RFI

WCSOTC

RFI #: 052

Subject: Duct in Room 141

Drawing: M211

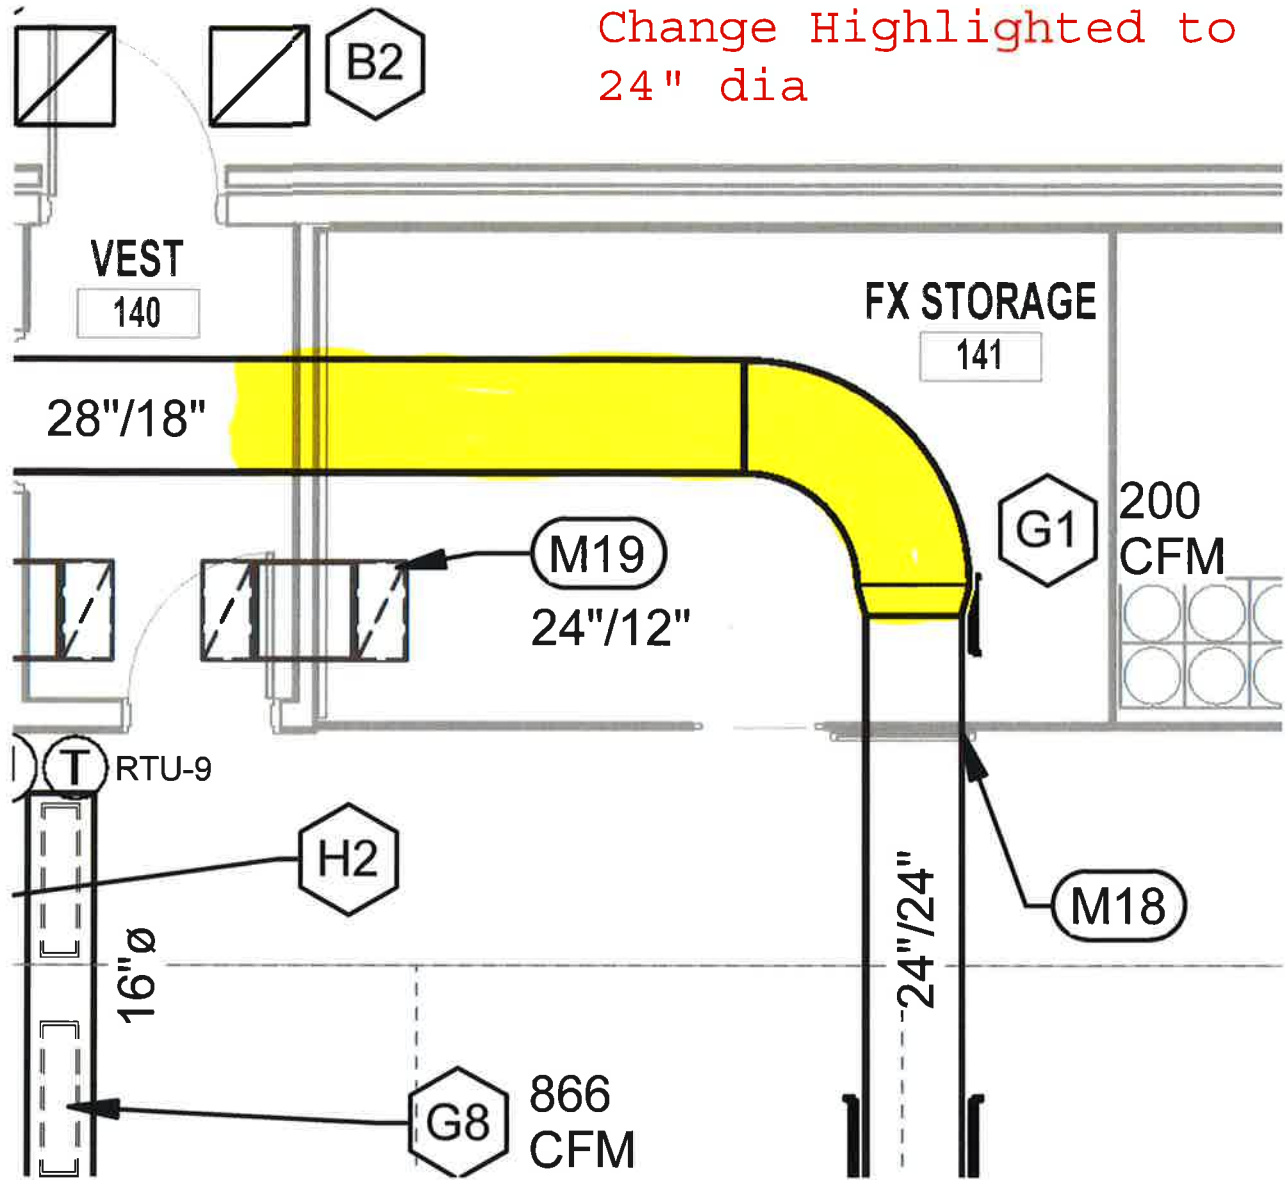
The ductwork over room 141 is shown to be 28"x18" Square wrapped with blanket insulation. Room 141 is a cage with the top of the cage at 10'0" above finished floor. This leaves this duct visible.
Please confirm this duct should be changed to spiral duct to starting in room 140 to match the duct in 143.

If the Owner and the Architect want this duct to be double walled spiral in this location, 24" round duct is equivalent to 28"x18" duct.

Refer to comments from HCE. Provide an estimate for the work for Owner review. DAA/BSWA 2017-08-30

Change Highlighted to 24" dia
